Staff Report Addendum

Tentative Subdivision Plat and Minor Variance

SD-03-23 & VR-03-24

May 24, 2024

WATER MAIN NOTES

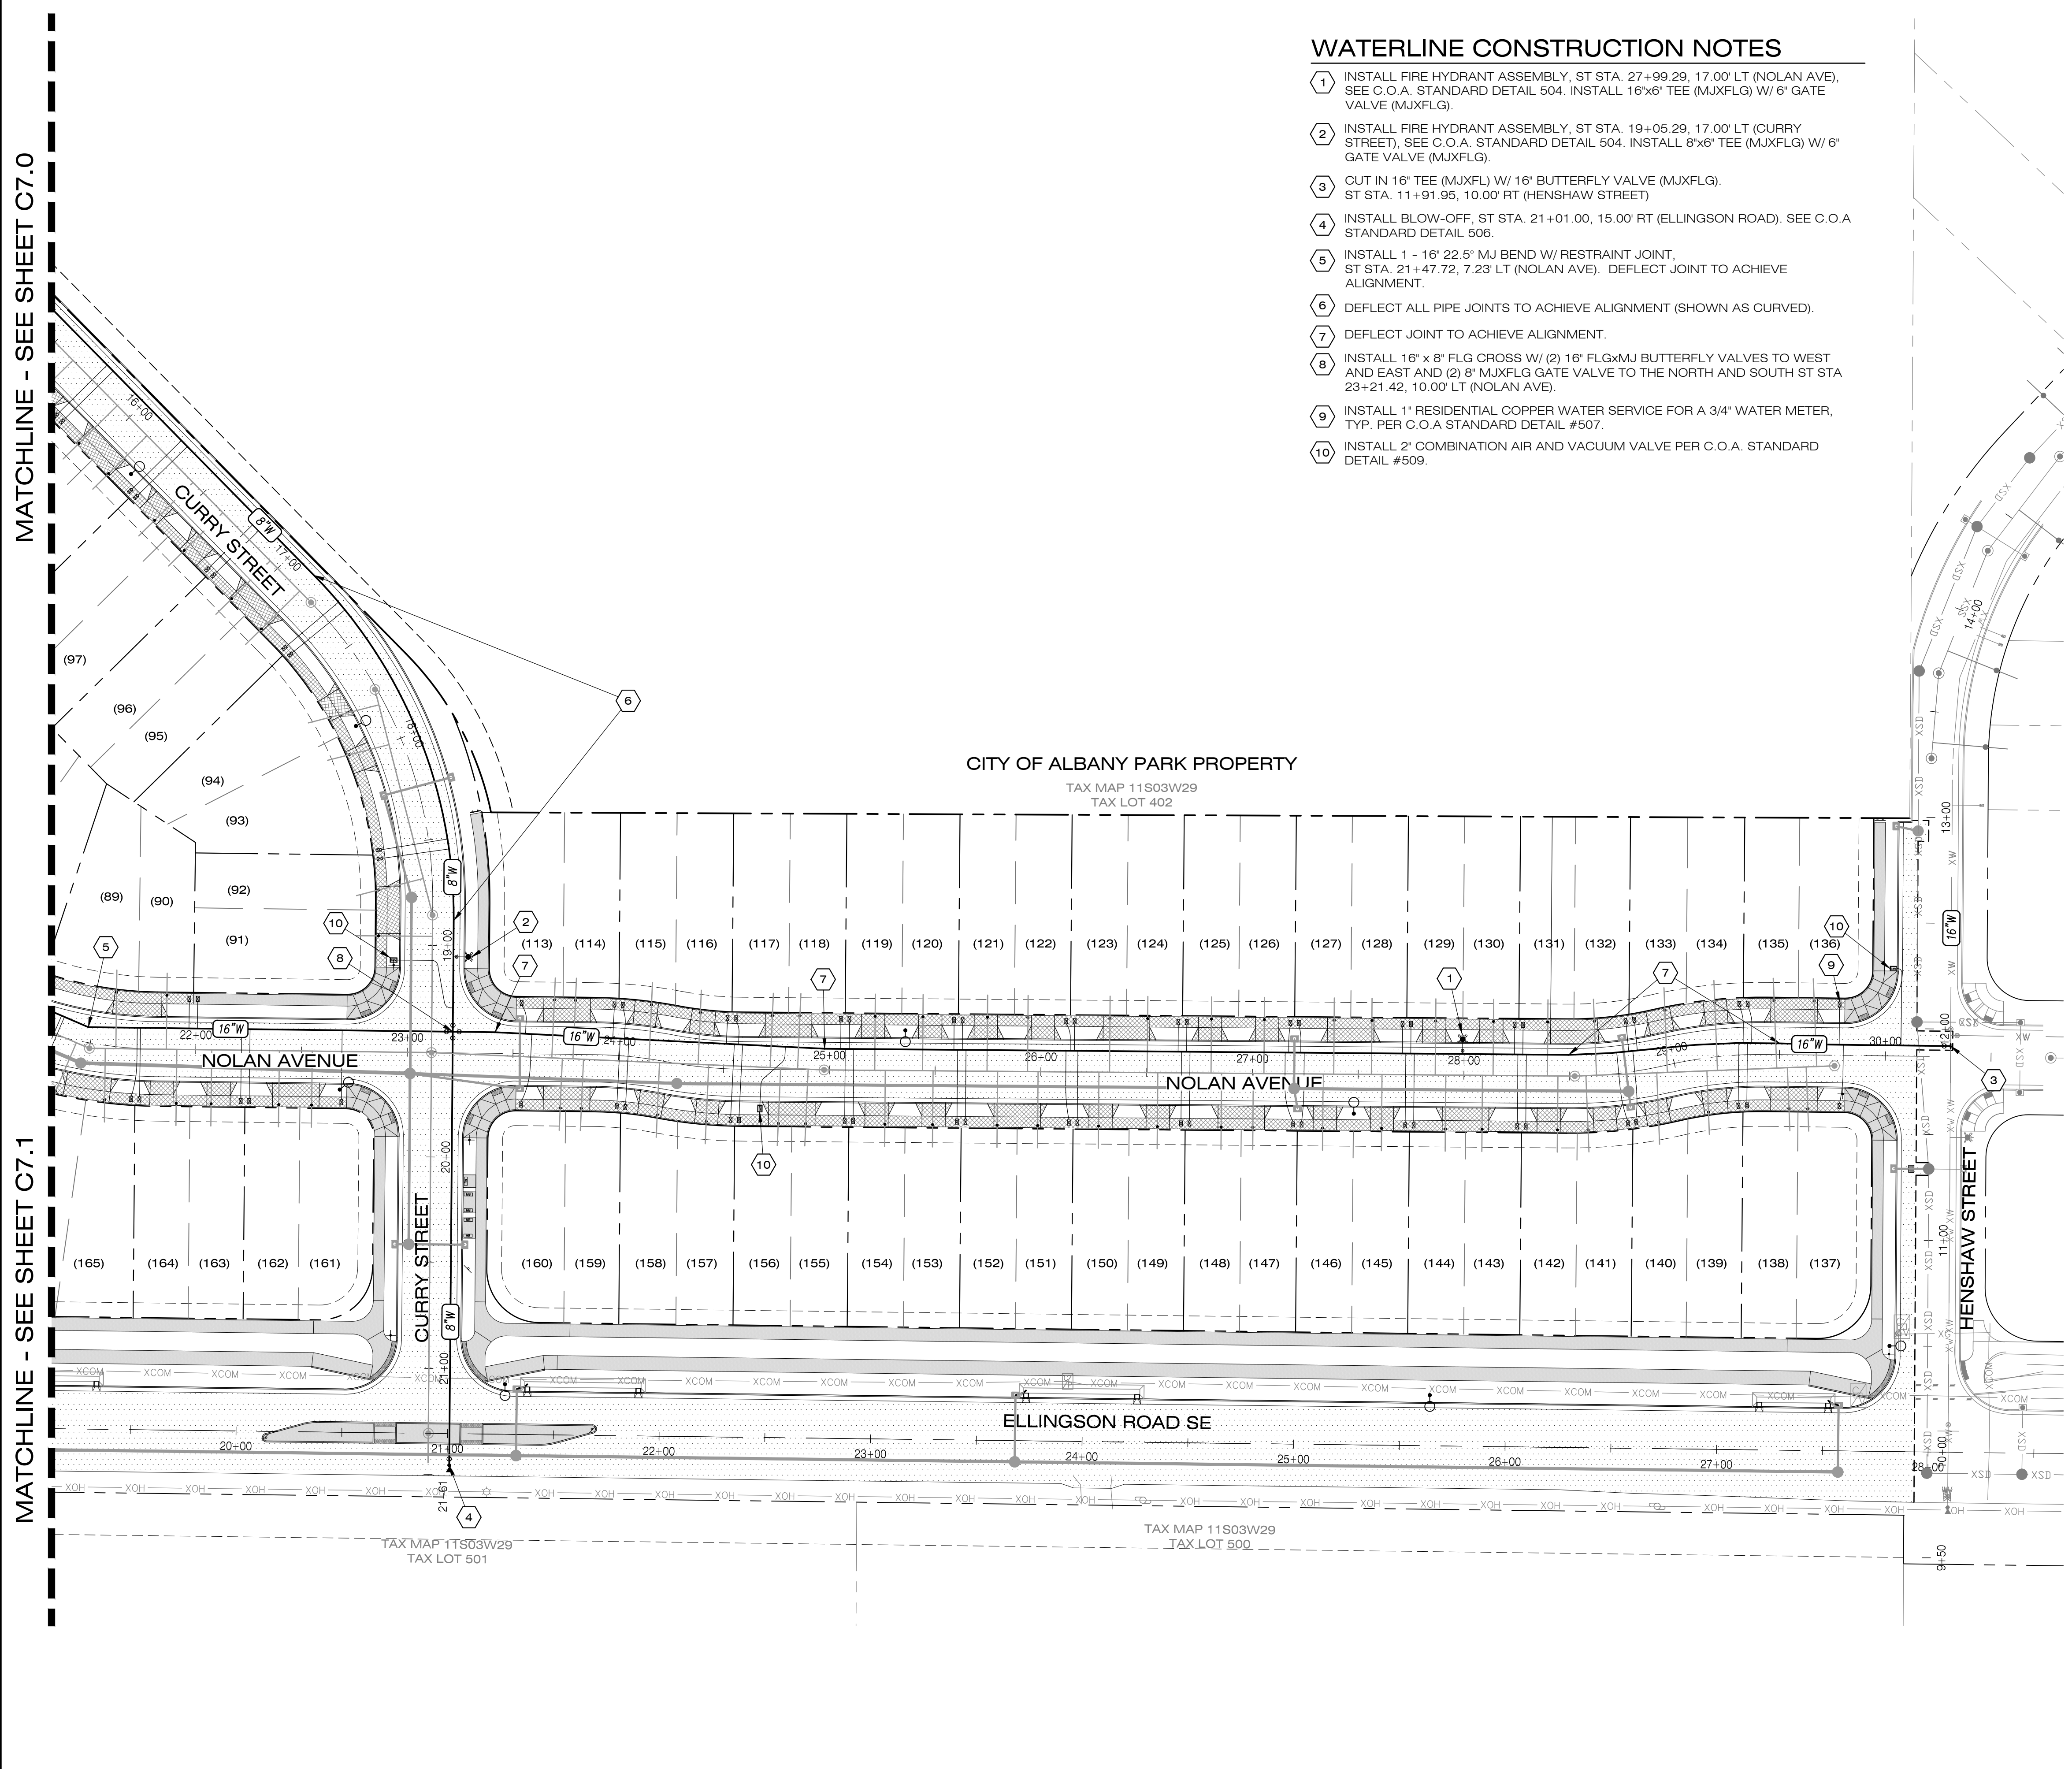
We are confused by this condition with what we understand is occurring on the north side of Ellingson Road regarding water master plan facilities.

Reviewing the Curry Meadows plans along with the Henshaw Farms project, a 16" water main is being constructed from the 24" water line in Lochner Road to Columbus Road. (some of the Curry Meadows water plan is attached)

We need Public Works to provide a much better explanation of the requirement and clarification of this projects responsibility.

Good morning Brian,
The water line is required for Curry Subdivision and is part of their plans to get it to the Lochner and Ellinson intersection. The timing of that work starting and being completed is unknown.
